# Addendum to the Environmental Study

in support of the  
Proposed East-West Connector, Northern Utah County

UDOT Project No. S-R399(12)

Project Name	Northern Utah County, East/West Connections (also known as East-West Connector)		
Project No.	S-R399(12)	PIN	5992
Prepared by	HDR Engineering, Inc. (Vince Izzo and Sue Lee)	Date	Original: 3/19/08 Revisions: 6/24/08
Address	3995 S. 700 E., Suite 100, Salt Lake City, UT 84107	Phone	(801) 743-7811

**Figure 4-5. Noise Impacts – Center Street to 300 East, Lehi**

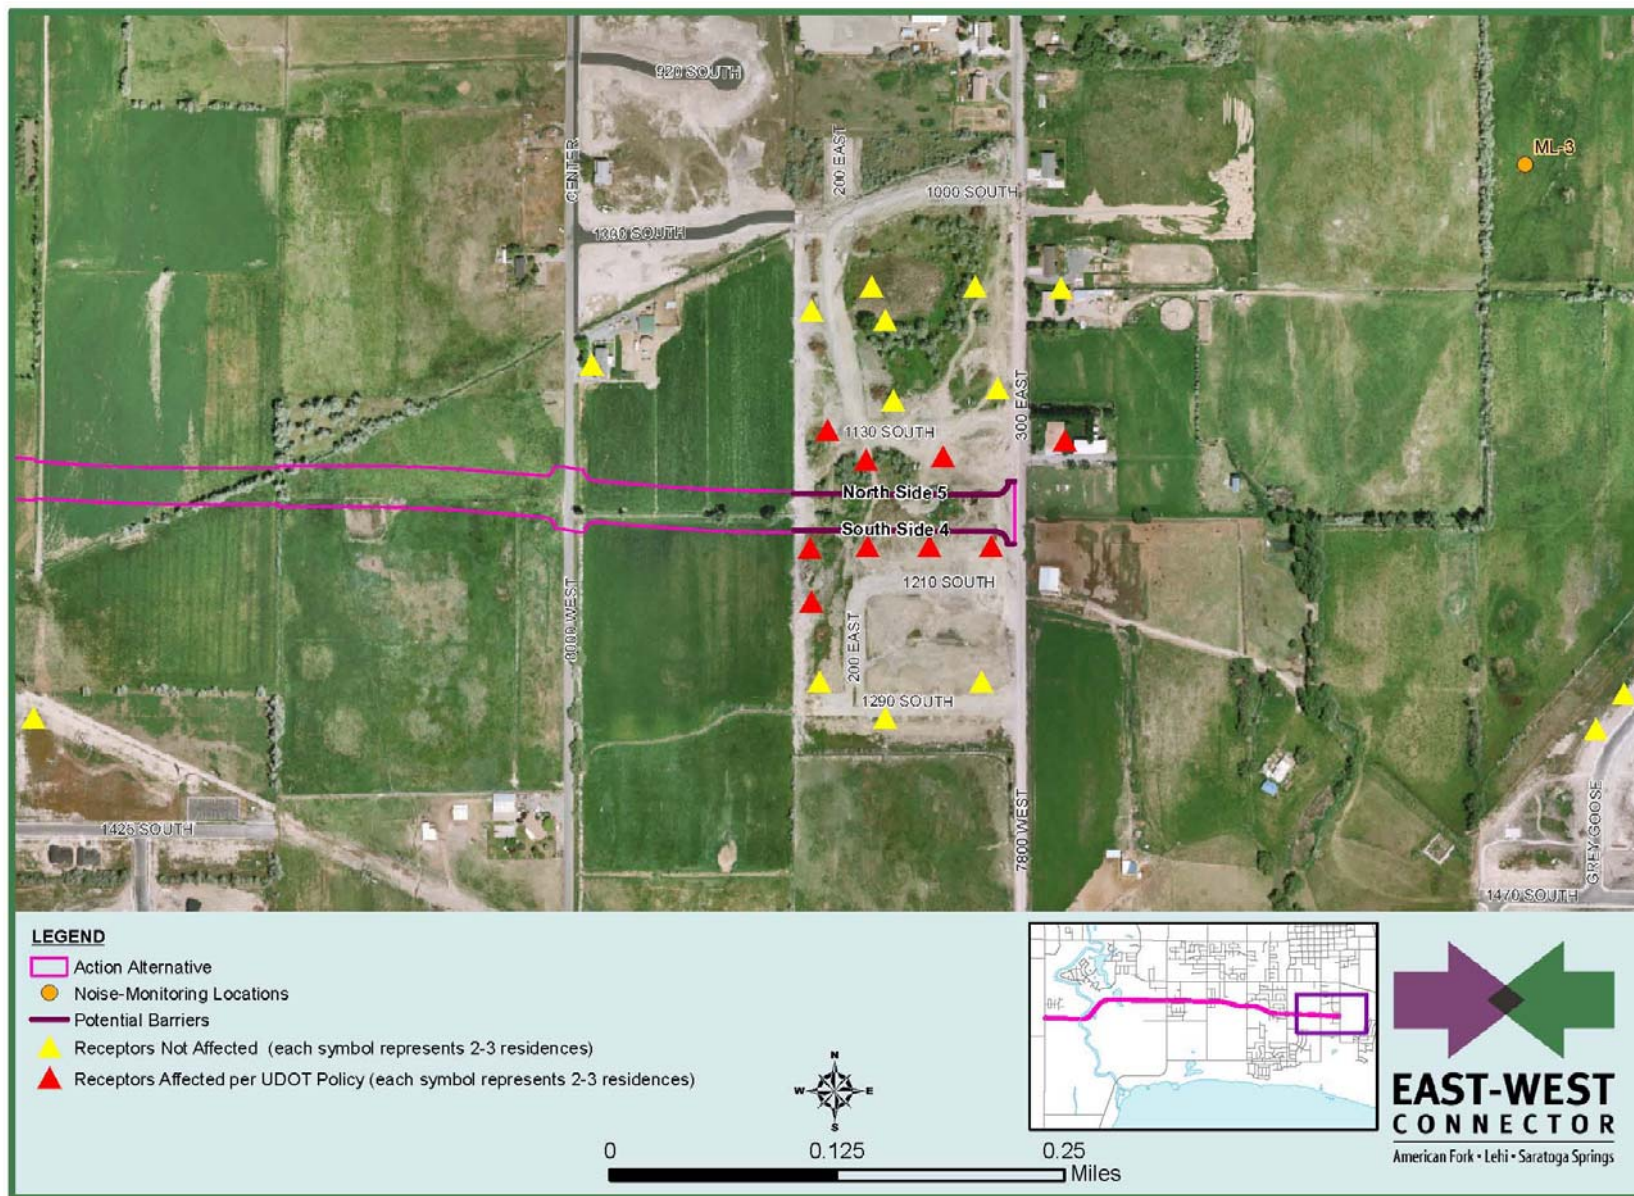
Barrier Site <sup>a</sup>	Reasonable and Feasible Based on Barrier Height? <sup>b</sup>					
	6 Feet	8 Feet	10 Feet	12 Feet	14 Feet	16 Feet
North side 1	Yes	Yes	No	Yes	Yes	Yes
North side 2	No	No	Yes	No	No	No
North side 3	No	Yes	Yes	Yes	Yes	Yes
North side 4	Not feasible at any height					
North side 5	<a href="#">No</a>	<a href="#">No</a>	<a href="#">Yes</a>	<a href="#">Yes</a>	<a href="#">No</a>	<a href="#">No</a>
<del>North side 5</del>	<del>Not feasible at any height</del>					
South side 1	Yes	Yes	Yes	Yes	Yes	Yes
South side 2	<a href="#">No</a>	<a href="#">No</a>	<a href="#">No</a>	<a href="#">Yes</a>	<a href="#">No</a>	<a href="#">No</a>
<del>South side 2</del>	<del>Not feasible at any height</del>					
South side 3	Not feasible at any height					
South side 4	Yes	Yes	Yes	Yes	Yes	<del>Yes</del> <a href="#">No</a>

*Figure 4-5 has been modified from the version in the March 2008 document. A new figure (Jordan Bank Stabilization Details) has been added to Chapter 4 as Figure 4-6. See the following pages for copies of these figures. The figures in Chapter 4 have been renumbered as follows:*

**Figure 4-6. Jordan Bank Stabilization Details**

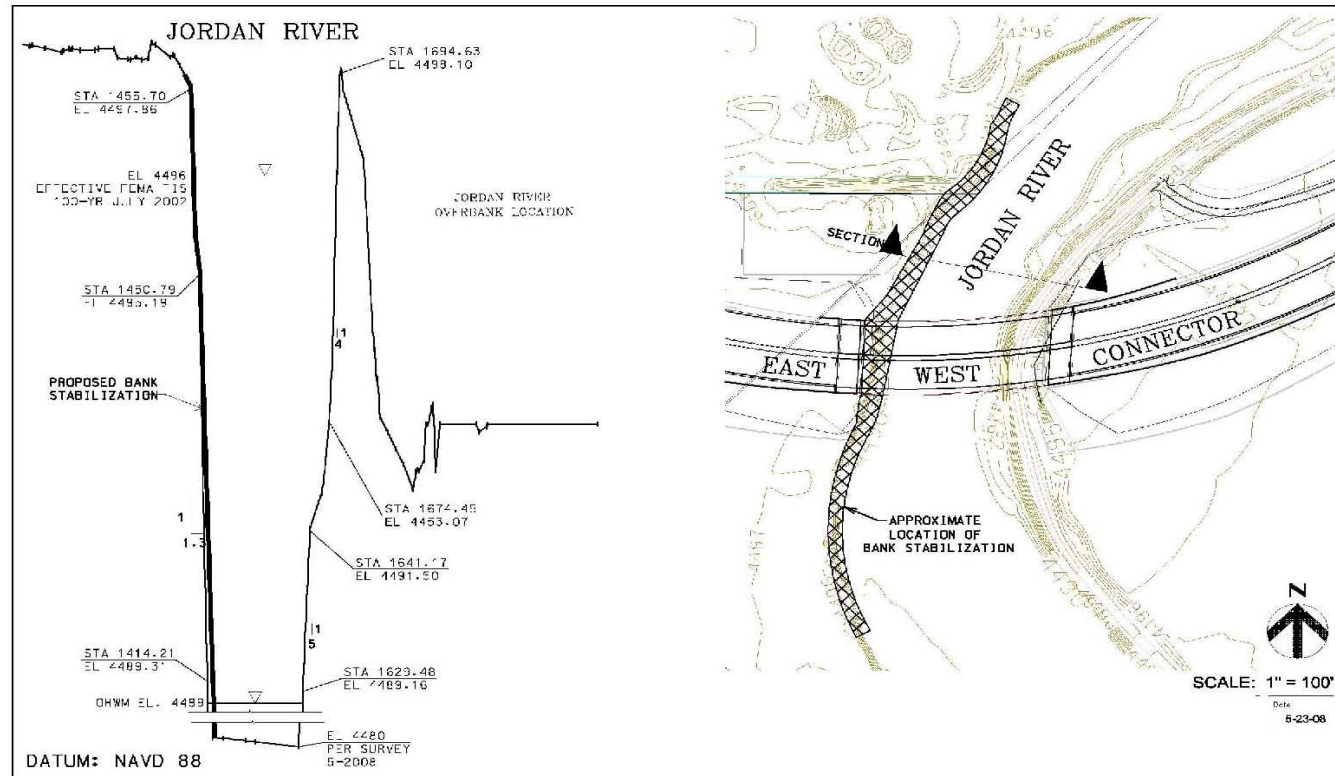
[Bank stabilization would be required at the Jordan River crossing due to existing hydraulic conditions. Stabilization would occur on the west bank of the river at the bridge site and in an area about 300 feet upstream and about 250 feet downstream of the bridge.](#)

The Jordan River would be crossed using a single-span bridge. Bank stabilization upstream of, downstream of, and under the bridge on the river's west bank would result in the discharge of a maximum of 311 cubic yards of material to a 0.19-acre area below the ordinary high-water mark (OHWM) of the river (the OHWM is the regulatory limit for the river under the Clean Water Act).
